LICENSE AUTHORITY FILE COPY  
UNITED STATES  
NUCLEAR REGULATORY COMMISSION  
WASHINGTON, D. C. 20555

The Commission has issued the enclosed Amendment No. 97 to Facility Operating License No. DPR-32 and Amendment No. 96 to Facility Operating License No. DPR-37 for the Surry Power Station, Unit Nos. 1 and 2, respectively. The amendments consist of changes to the Technical Specifications in response to your application transmitted by letter dated May 4, 1983, as supplemented September 23, 1983, and January 11 and February 3, 1984.

These amendments revise the Technical Specifications to incorporate the requirements of Appendix I of 10 CFR Part 50 as Radiological Effluent Technical Specifications (RETS).

SURRY POWER STATION, UNIT NO. 1

Figure 1. Liquid Radwaste Treatment Systems, Effluent Paths, Turbine Building Sump, Station Storm Drain System, and Controls for Surry Power Station Units 1 and 2

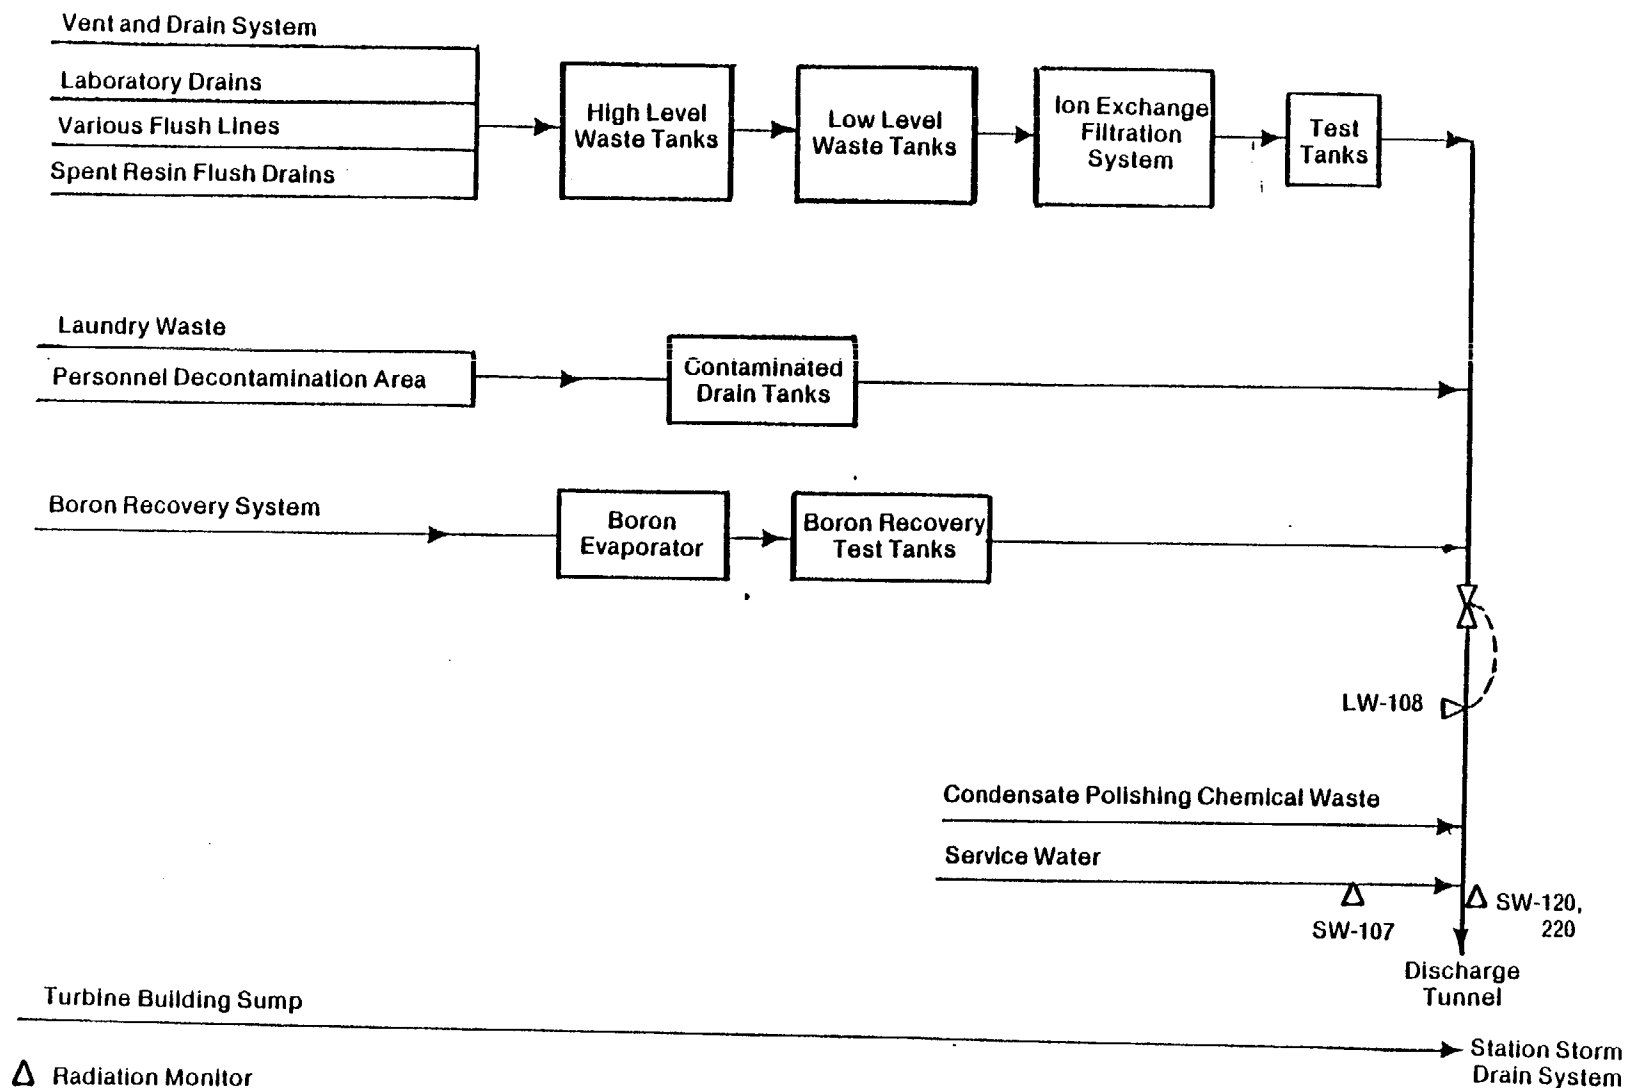
The liquid waste treatment system for the Surry plant is common to both Units 1 and 2 (Figure 1). Two systems currently exist for treating liquid wastes. These are the boron recovery system and the liquid waste treatment system. The boron recovery system treats effluents collected in primary drain tanks and letdown from the primary coolant that is diverted from the chemical and volume control system (CVCS). The liquid waste treatment system processes the liquid waste originating from containment, auxiliary building, and decontamination building sumps, and from laboratory drains. These effluents are all released in batches, which join to form the liquid radwaste effluent line, providing ultimate discharges to the bay via the discharge tunnel.

A radiation monitor (LW-108) has been installed for the liquid radwaste effluent line (Figure 1), which provides automatic isolation in the event that an excessive level of radioactivity is detected. The Licensee has also provided a monitor (SW-107) for the service water and two monitors (SW-120, 220) for the discharge tunnel.

Figure 2. Gaseous Radwaste Treatment Systems, Effluent Paths, and Controls for Surry Power Station Units 1 and 2

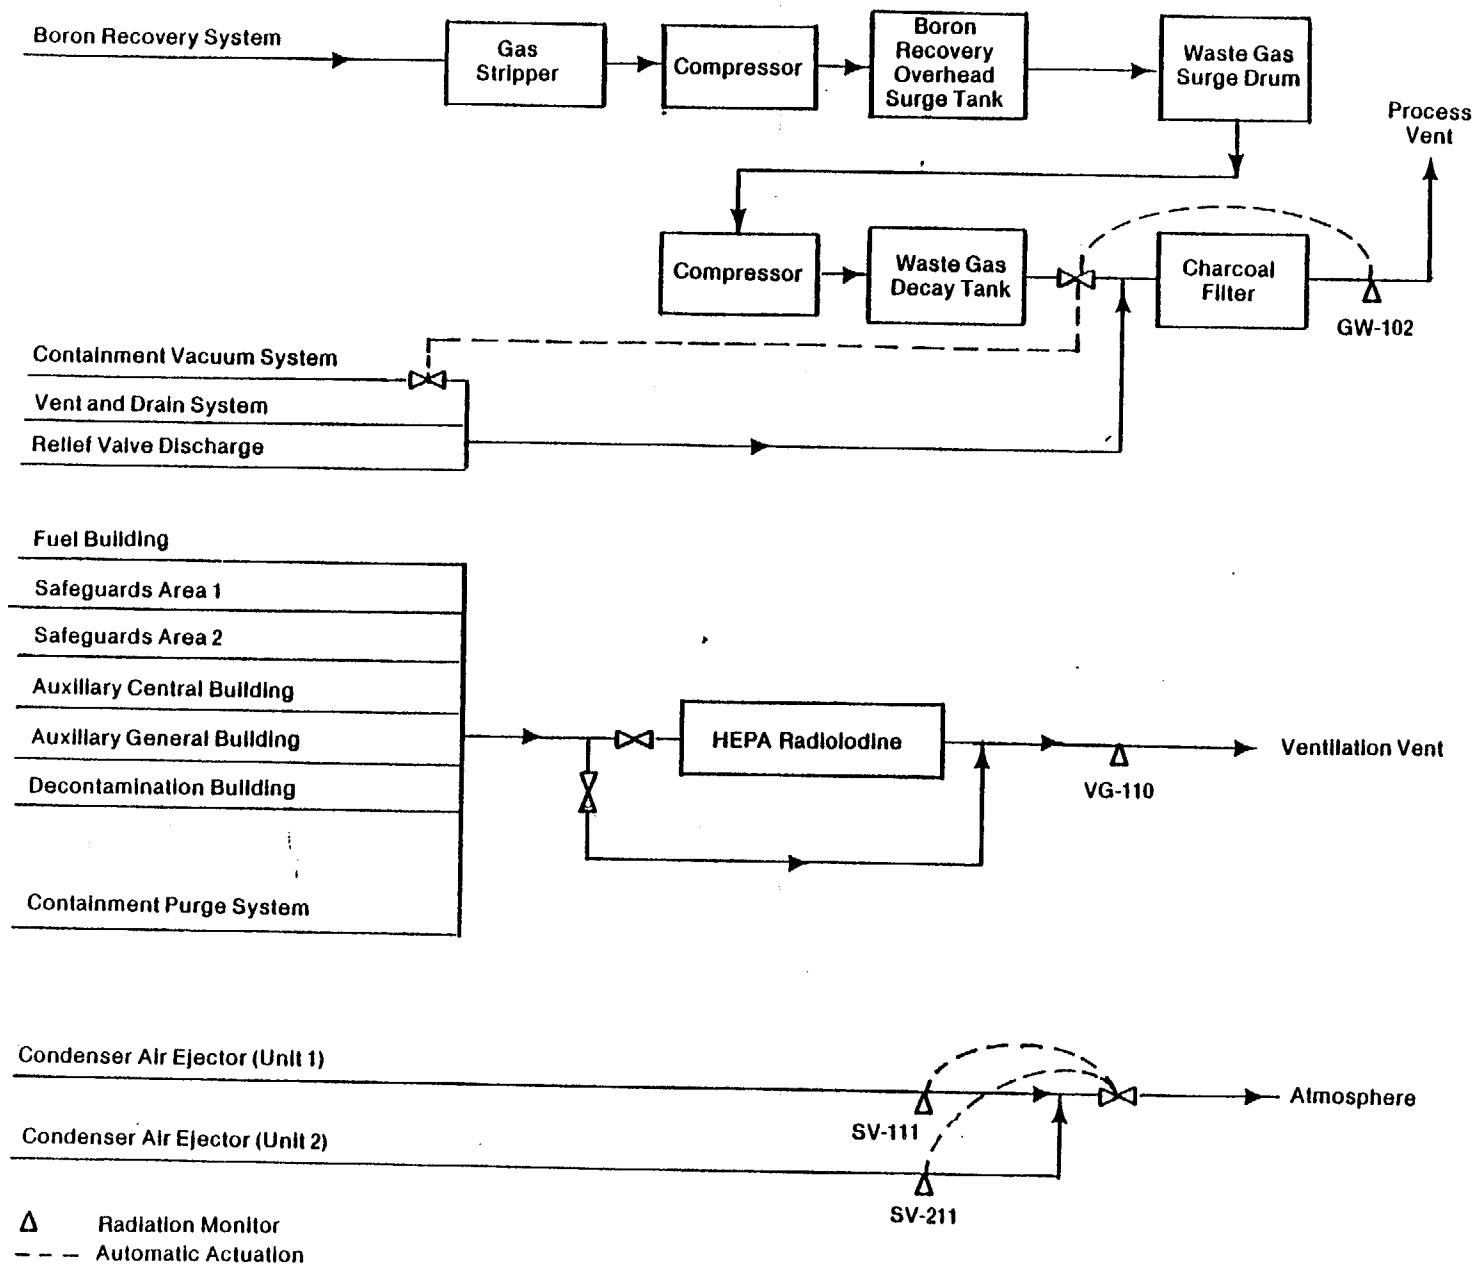
The gaseous waste treatment system for the Surry plant is also common to both Units 1 and 2 (Figure 2).

The plant process vent is provided with a monitoring system capable of monitoring noble gases, iodines, and particulates. The noble gas monitor (GW-102) has the capability of automatically isolating the releases from the waste gas decay tank and the containment vacuum system. Radiation monitors are also installed at the condenser air ejectors; monitor SV-111 for Unit 1 and monitor SV-211 for Unit 2 both have the automatic isolation capability on the discharges. Radiation monitor VG-110 monitors the effluent releases through the ventilation vent.
